KITCHEN (APT. NO. 2)
FLOREA 'D'.

CIVIL LAYOUT

ELEVATION - A

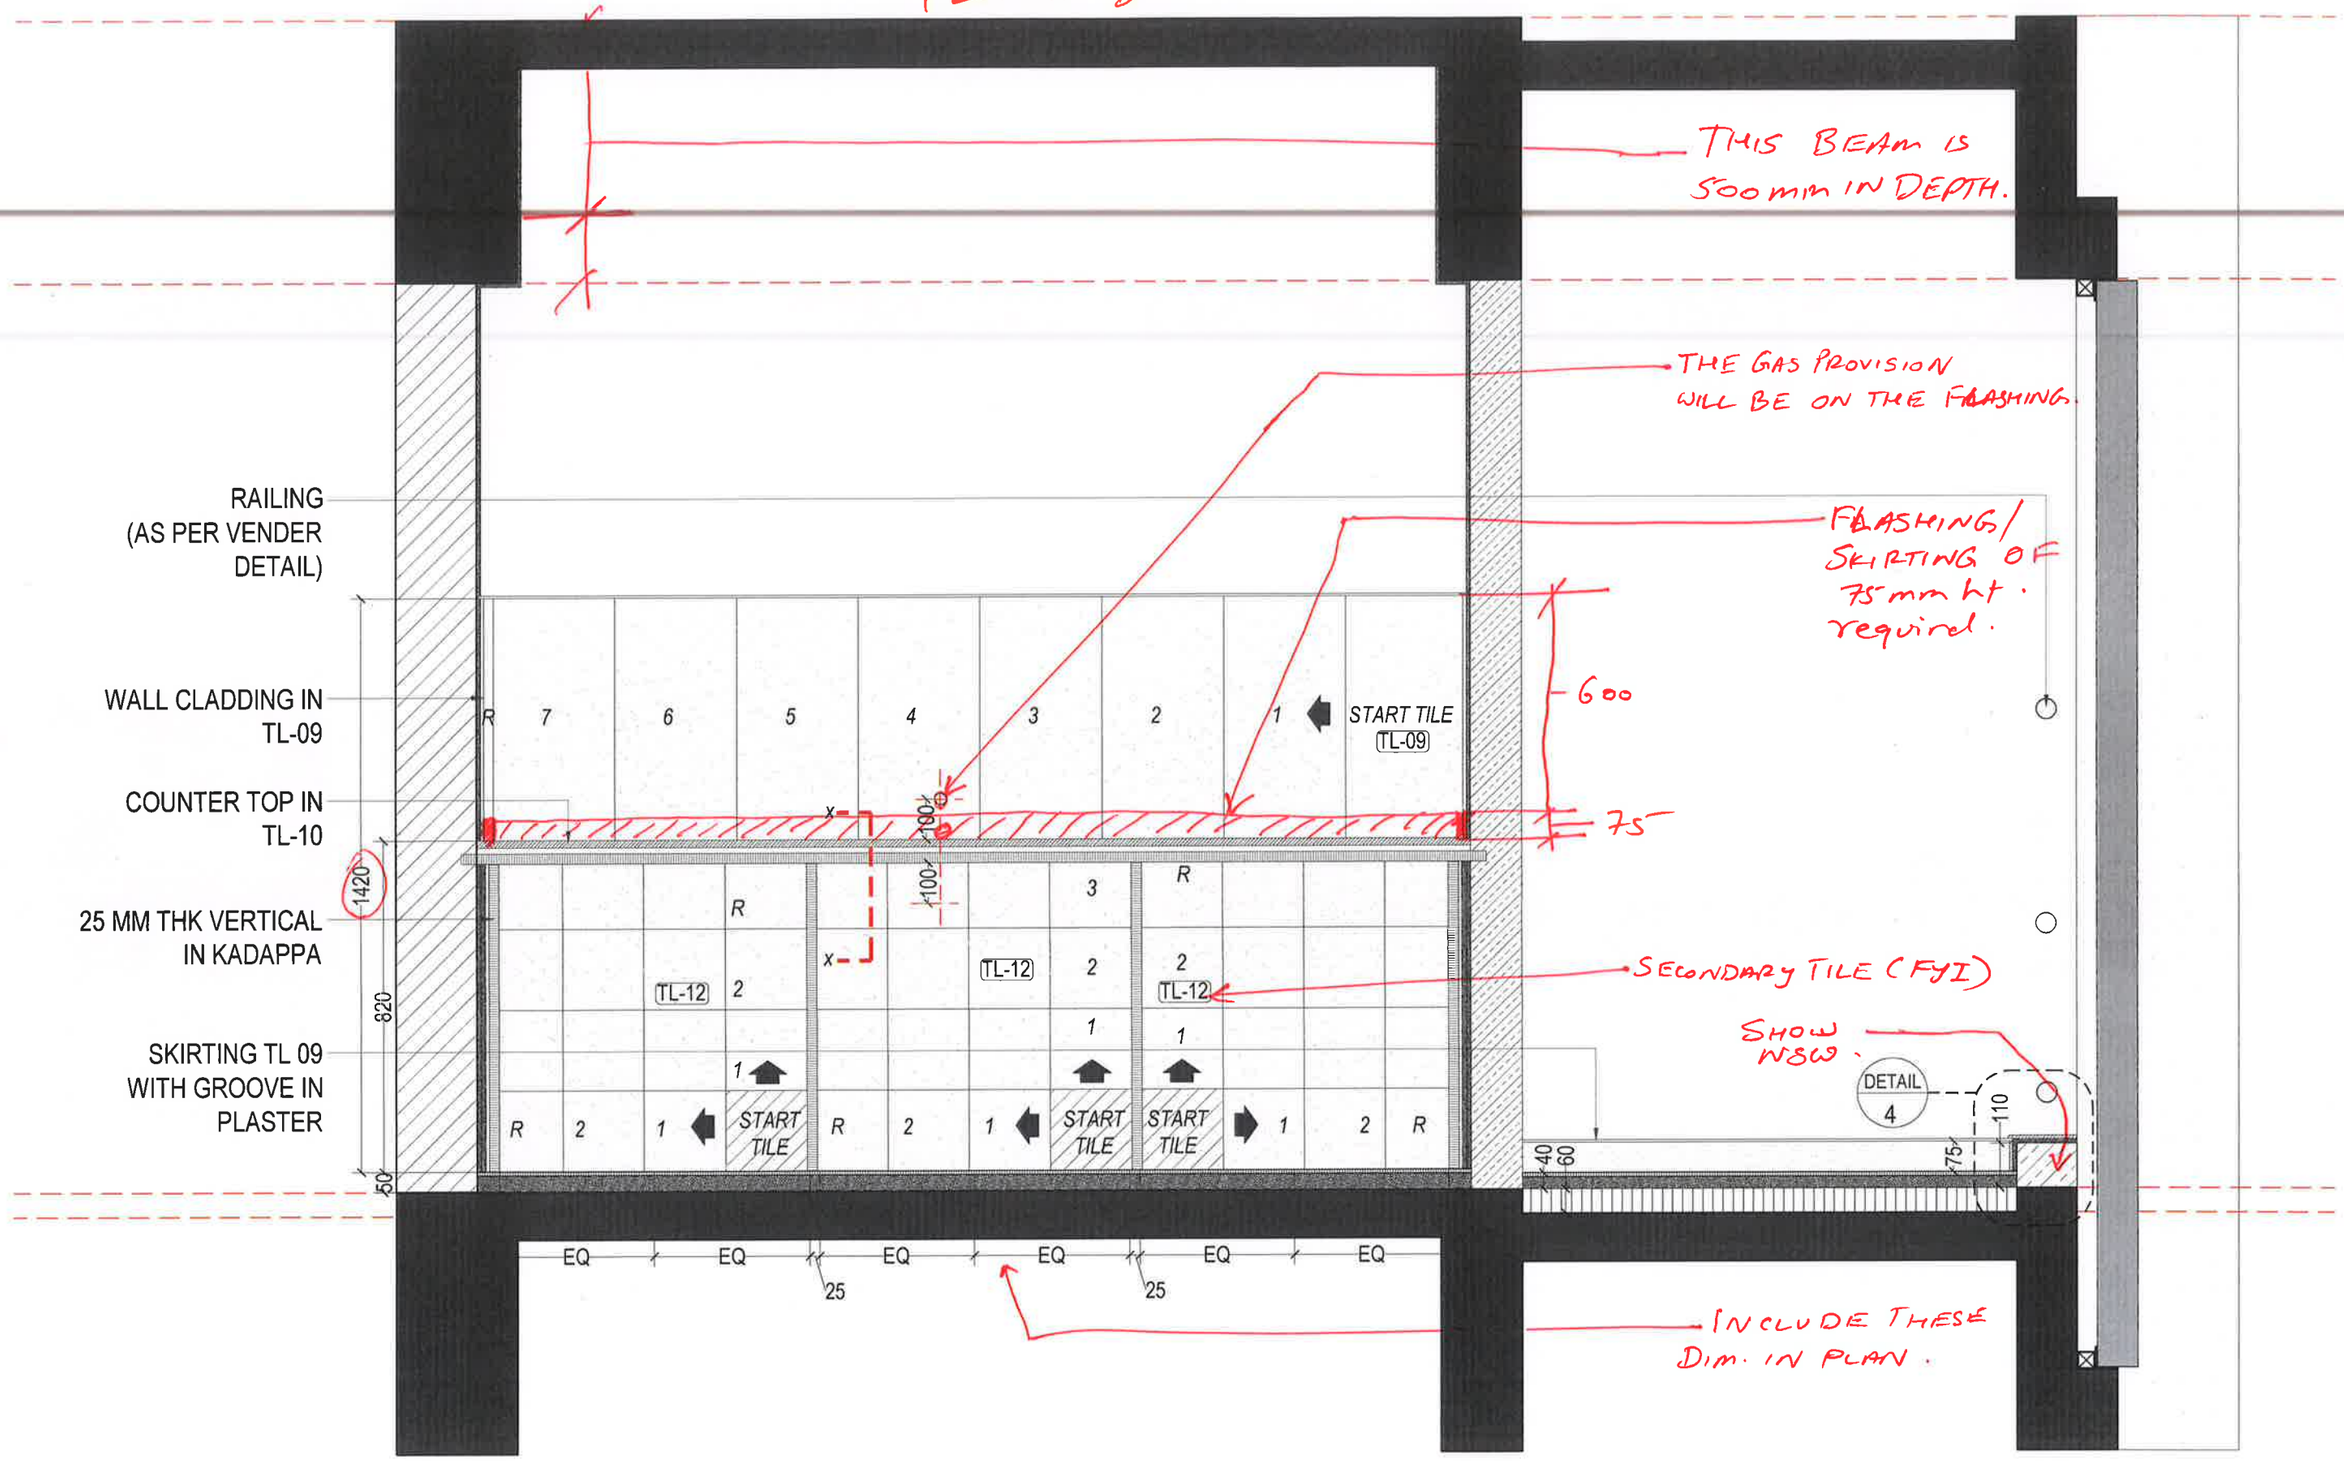
BEAM DEP
IS 500(300W)
& DROP PARDI

K-03 SB CAN BE ~~ALIGN~~ ALIGNED WITH TILE JOINT.

SHIFT.

MENTION SKIRTING & ITS HT.
